<b>Location:</b>	<b>3308 Grand Avenue</b>
<b>Assessor's Parcel Number:</b>	<b>011 083603100</b>
<b>Proposal:</b>	An appeal of the Zoning Manager's Approval of an application to construct a two-story rear addition and reconstruct existing rear building area for a total 1,582 square feet (net 575 square feet of added building floor area) to an existing two-story Full Service Restaurant, Boot and Shoe Company
<b>Appellants:</b>	Carl Telson and Sz Jou
<b>Phone Number:</b>	(415) 271-5004 (Appellants)
<b>Owner:</b>	Richard Weinstein
<b>Case File Number:</b>	<b>PLN15-058-A01</b>
<b>Planning Permits Required:</b>	Regular Design Review
<b>General Plan:</b>	Neighborhood Center Mixed Use
<b>Zoning:</b>	CN-2 Neighborhood Commercial
<b>Environmental Determination:</b>	<u>Staff Environmental Approval PLN15-058, October 23, 2015</u> Exempt, Section 15301 of the State CEQA Guidelines: Existing Facilities (operation) Section 15183 of the State CEQA Guidelines: Projects Consistent with a Community Plan, General Plan or Zoning

# CITY OF OAKLAND PLANNING COMMISSION

Case File: PLN15058-A01

Address: 3308 Grand Avenue

OWNER: PROJECT NUMBER: SHEET NUMBER: SHEET TITLE: PROPOSED ELEVATIONS

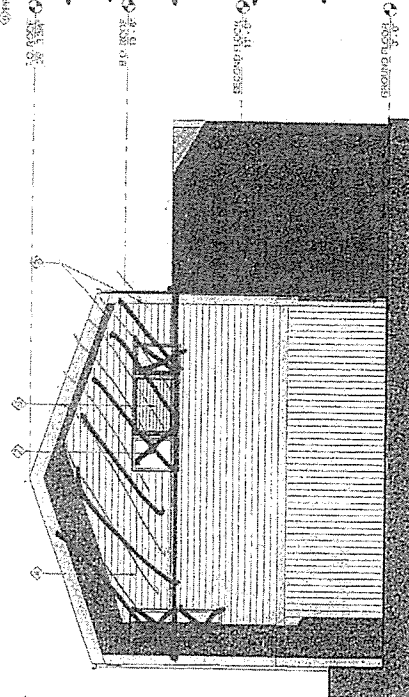
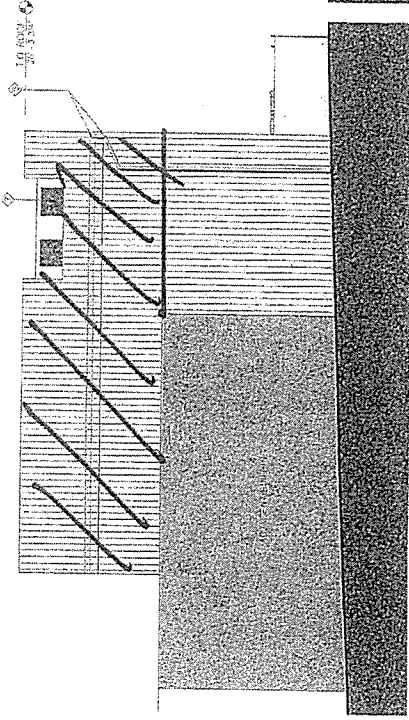
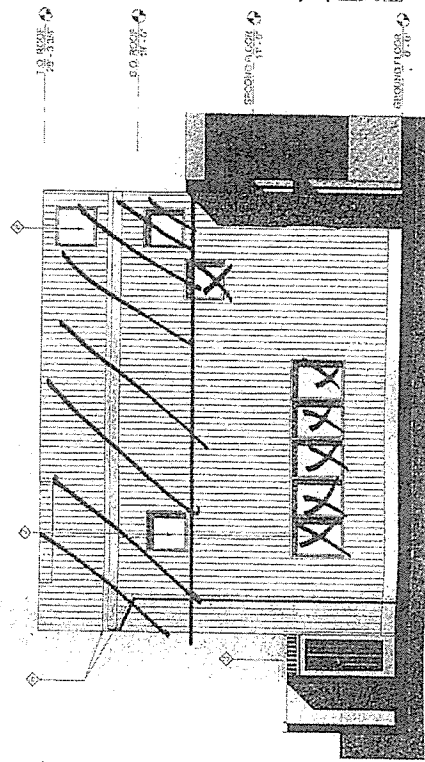
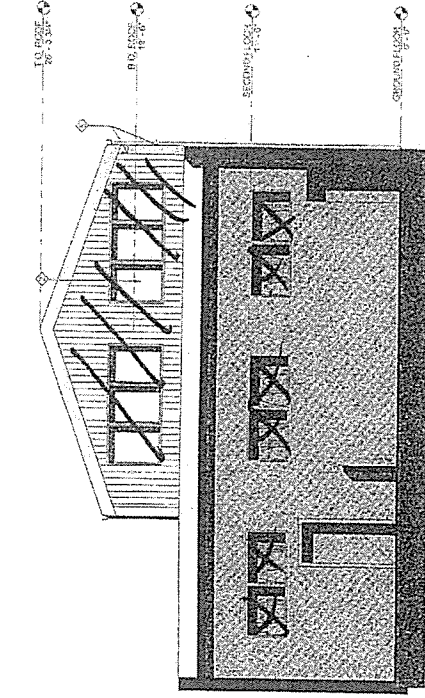
- 1. RESTAURANT
- 2. ON SITE WINDOWS
- 3. ON SITE SILL CASE
- 4. TOUGH OVERHEADS AT 60 DEGREES ANGLE
- 5. EXTENDED VERTICAL LINE CLAD IN TO BEHIND WALL
- 6. PREPARED ROOF SILLER AND DRAINAGE
- 7. ROOF TOP MECHANICAL UNIT ENCLOSED
- 8. MECHANICAL GLAZED SKYLIGHT
- 9. PREPARED HORIZONTAL VENTILATION

- completely enclosed structure
- No outdoor patio / sitting
- No windows
- Stationary skylight
- completely sound proofed
- the addition not higher than the existing structure

PROPOSED  
ELEVATIONS

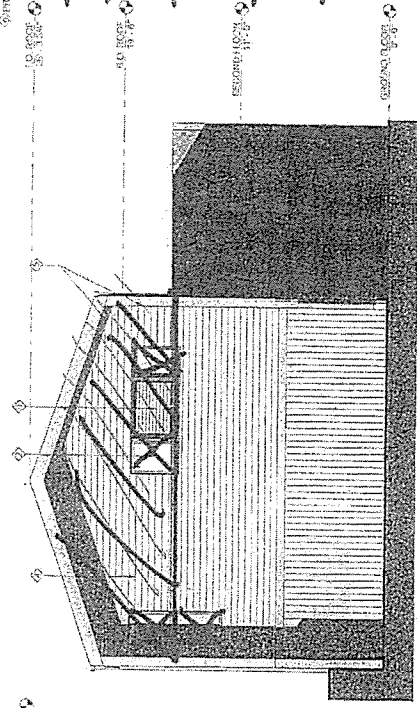
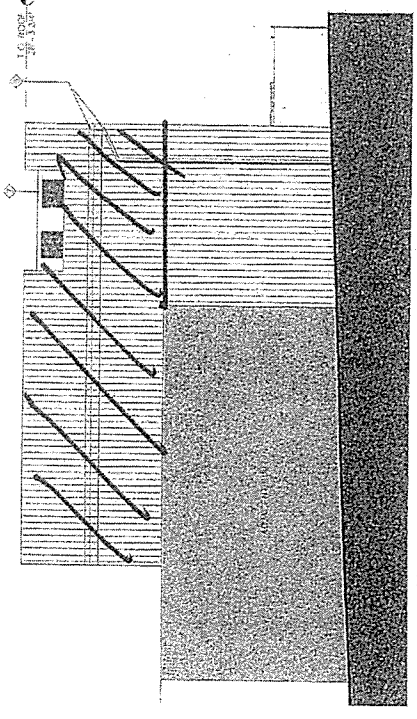
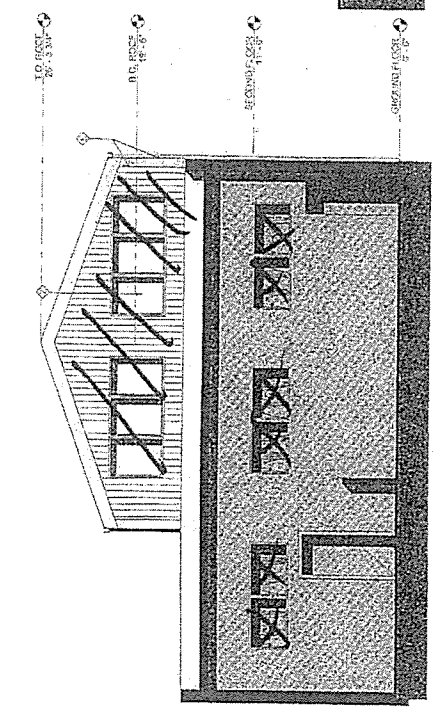
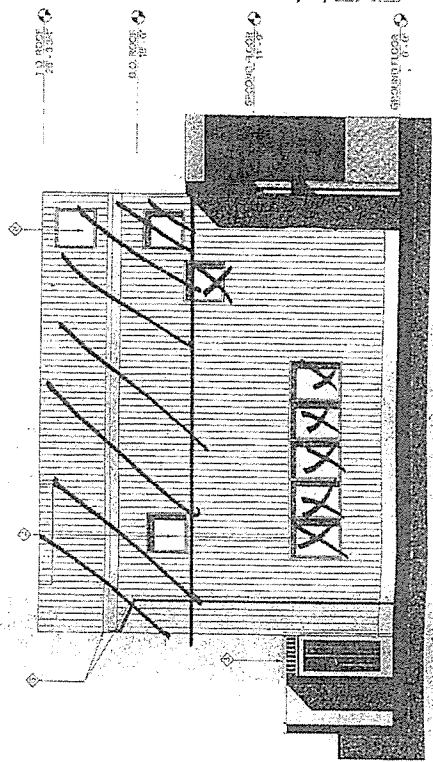
- 1. NO RESTAURANT
- 2. NO STEEL WINDOWS TYP
- 3. NO PIVOT CASE
- 4. NO TROUGH OVERHANGS AT GLAZED STORY WINDOWS
- 5. EXTERIOR "PORTAL" GLAZED GLAZED BUILT UP WALL
- 6. PREHANGED PORTAL GLAZED GLAZED BUILT UP WALL
- 7. PORTAL MECHANICAL UNIT ENGAGED
- 8. NO ACRYLIC GLAZED SKYLIGHT
- 9. INTERIOR HORIZONTAL METAL SLATS

*- completely enclosed structure*  
*- No outdoor patio / sitting*  
*- No windows*  
*- Stationary skylight*  
*- completely sound proofed*  
*- the addition not higher than the existing structure*

PROJECT NAME  
BOOT AND SHOE  
SERVICE  
ADDITION  
PROJECT NUMBER  
1-1-00  
SHEET DATE  
1/1/00  
SHEET NAME  
PERSPECTIVES

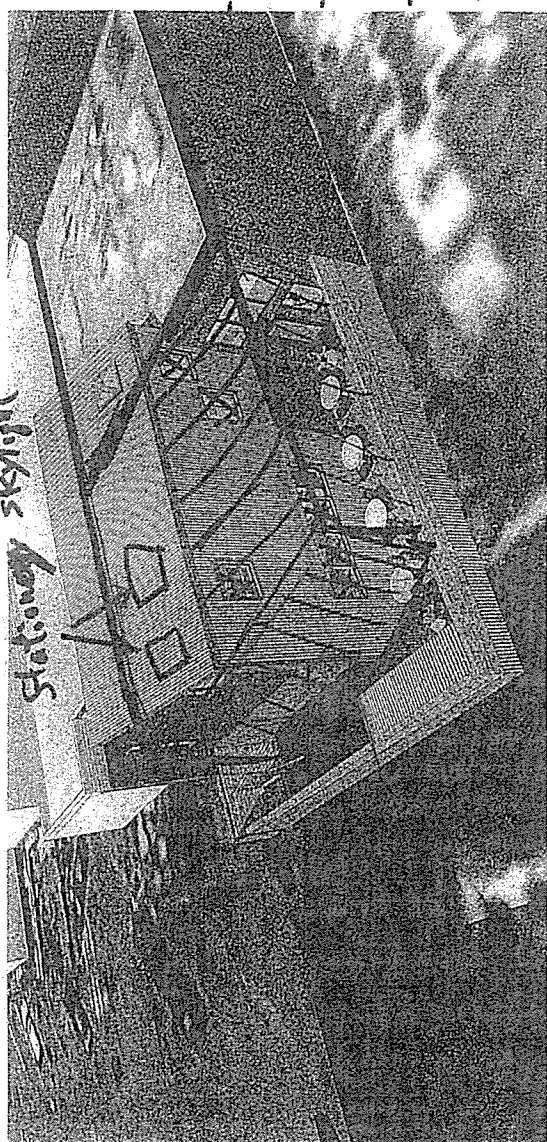
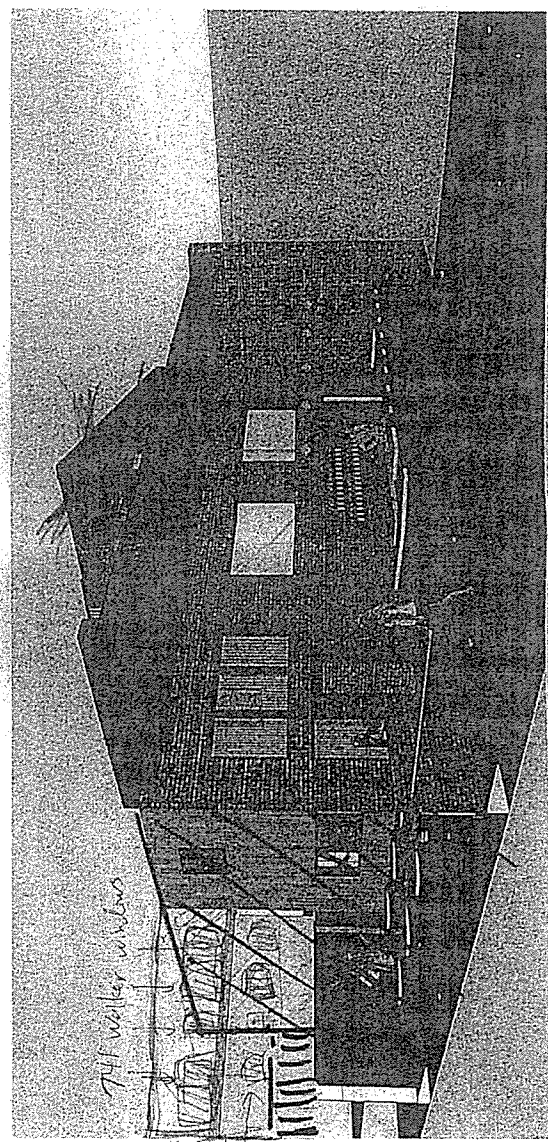
741 Walker windows

741 Walker  
House

741 Walker Deck
